Our Ref: LF/23061

Response to Consultation Comments S62a Application S62A/2024/0057 Former Friends School Field, Mount Pleasant Road, Saffron Walden, CB11 3EB

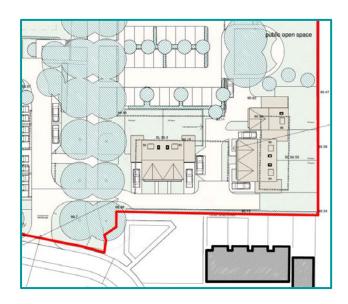
The comments regarding the delivery of the cycle connection to the west are noted, however the proposal seeks to connect to a residual grassed area and not parking, as shown in the below extract.
